Item 3.**Development Application: 26-28 and 34 Pirrama Road, Pyrmont - D/2021/1445**

File No.: D/2021/1445

Summary Recommendation: This proposal is recommended for refusal.

Figure 16: Extract of approved plan granted under D/2020/942, showing the approved indoor and outdoor seating layout

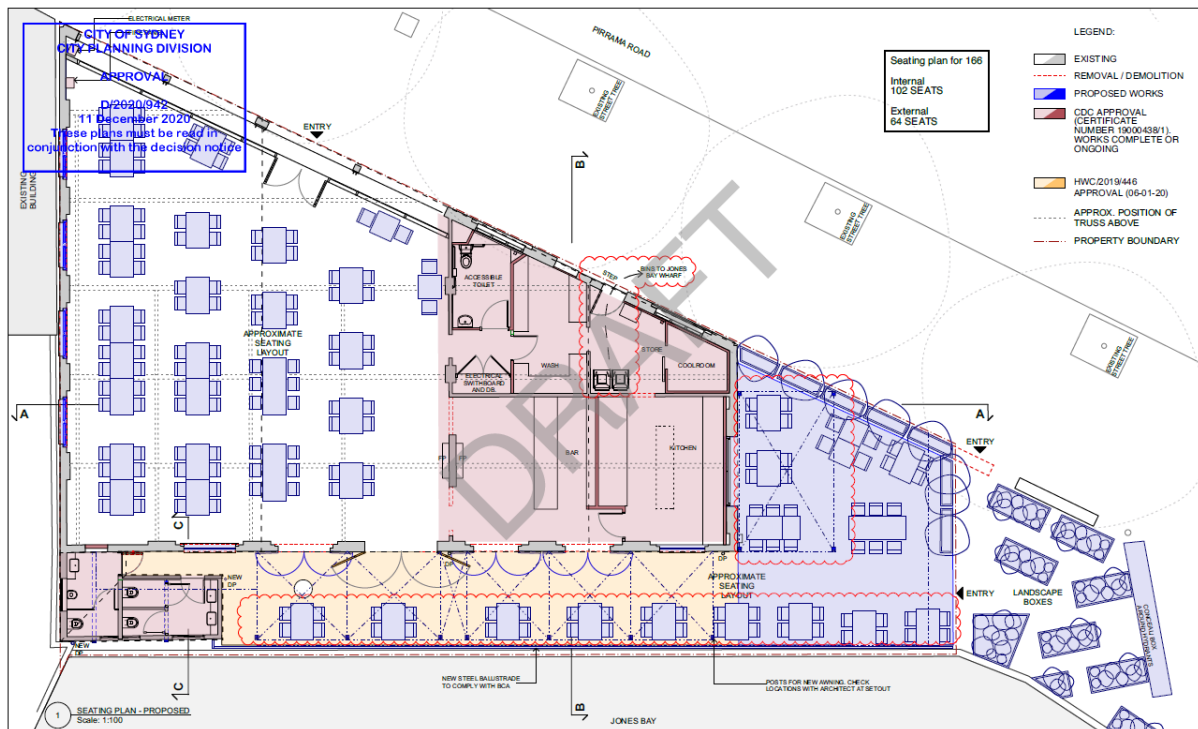
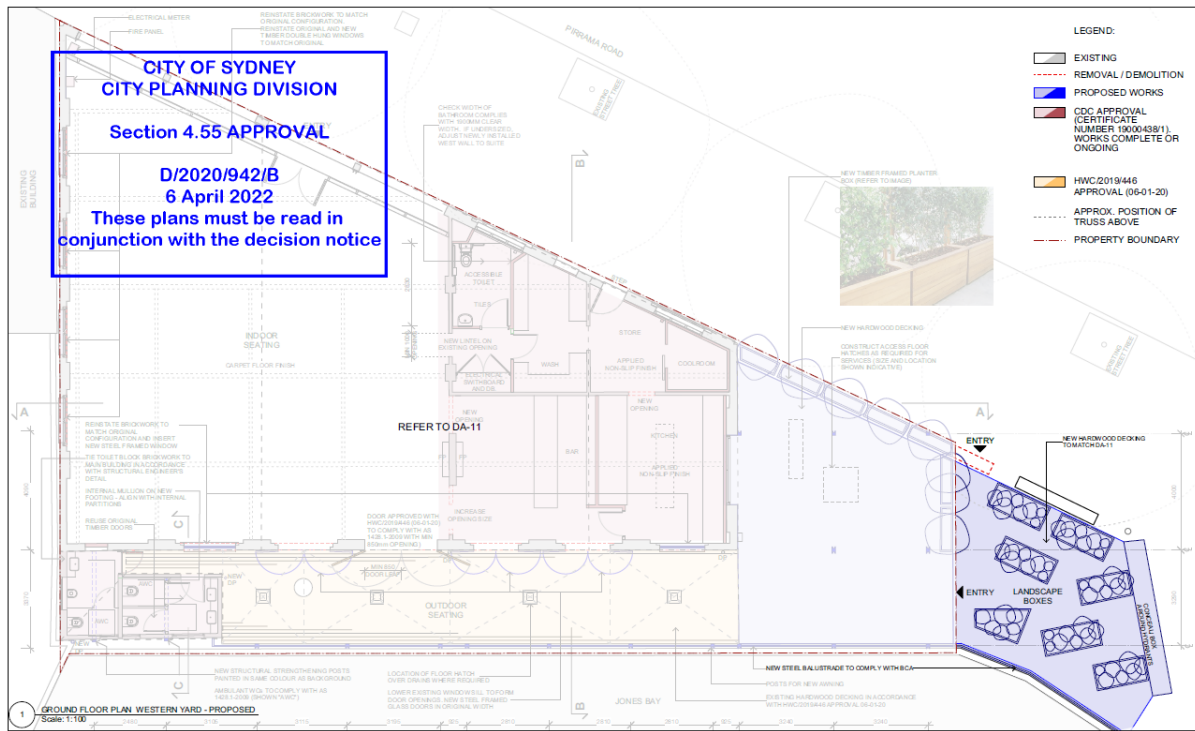
- Use of the northern outdoor terrace area after 8.00pm as a thoroughfare to the amenities serving the site.
24. The approved plan for the restaurant use (Figure 16) suggests that the area shown in orange is the "northern terrace" and the area shown in purple is the "western terrace". The plans and accompanying reports submitted as part of the subject DA, however, do not define the "western terrace" and "northern terrace" areas (see Figure 19 and Figure 20).

62. The proposed and approved DA plans also indicate that the western portion of the terrace will be provided with landscape planter boxes that will restrict use of this area (see Figure 16, Figure 17, Figure 19 and Figure 20). An inspection of the site revealed, however, that the planter boxes have not been configured as shown on the plans and as a result, provides a larger outdoor area (see Figure 5). While the PoM states that guest numbers on the western terrace between 6.00pm and 8.00pm will not exceed 18 persons, the PoM is silent in terms of the maximum capacity prior to 6.00pm. Any proposal to increase the useable portion of the terrace would not be supported and is not supported by any documentation submitted by the applicant.

Figure 19: Proposed seating plan option A, noting that the configuration is for 130 instead of 110 patrons

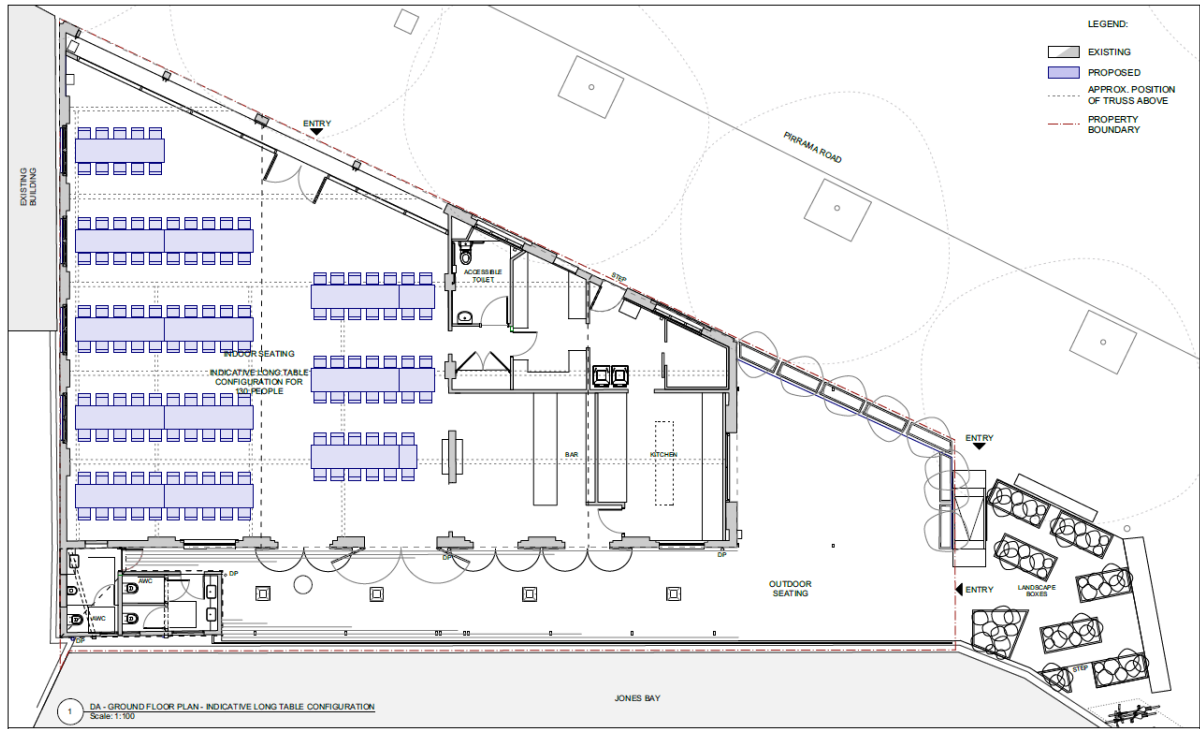
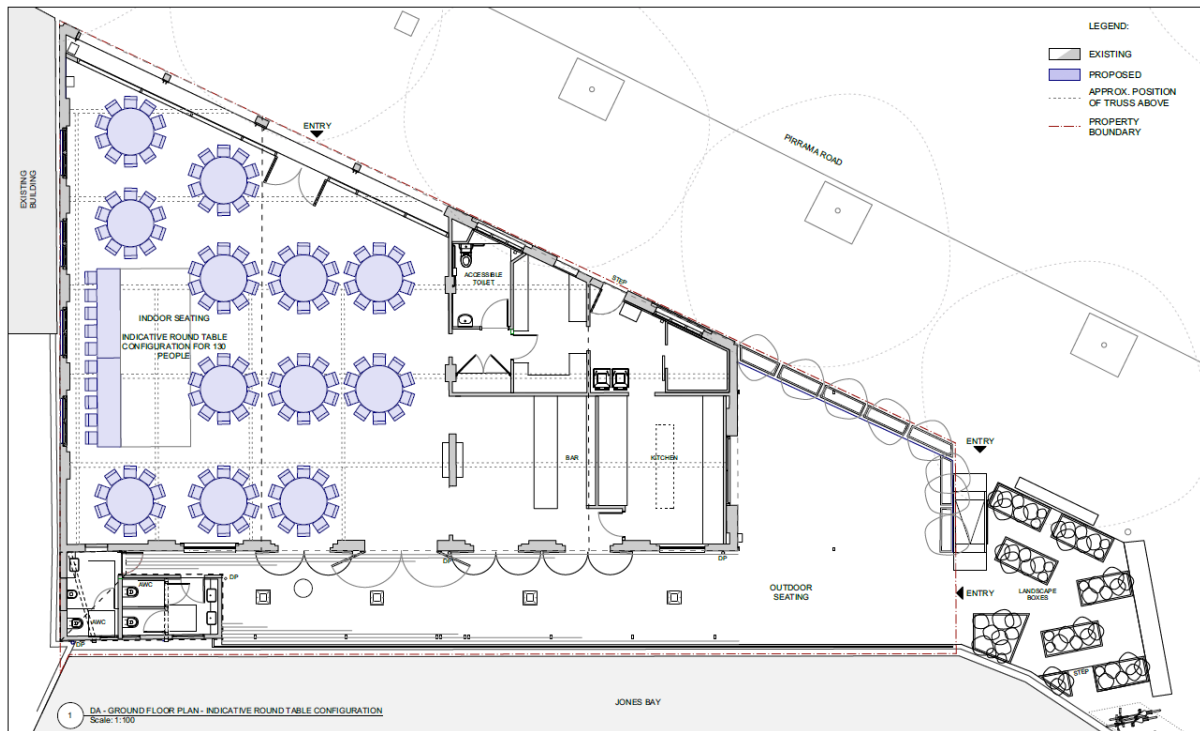
- A maximum capacity of 110 patrons when being used as a function centre, including indoor seating for 110 guests (although the plans show indoor seating for 130 patrons). No outdoor seating is proposed when being used as a function centre (although the plans do nominate outdoor seating).

The submitted DA documentation, including the accompanying PoM, Acoustic Report and DA plans, do not define the “western terrace” and “northern terrace” areas. Furthermore, the application has not demonstrated that the capacity limitations (which have been established for the seated restaurant use) are appropriate for the proposed function centre use.

- (b) The PoM fails to explain how the maximum nominated patron numbers will be managed, especially given that there will be no outdoor seating and that guests will be able to move freely throughout the terrace area. The wrap around terrace also provides no physical barrier between the northern and western terrace areas (see Figure 4) and as such, it will not be possible to contain patrons to one particular area.
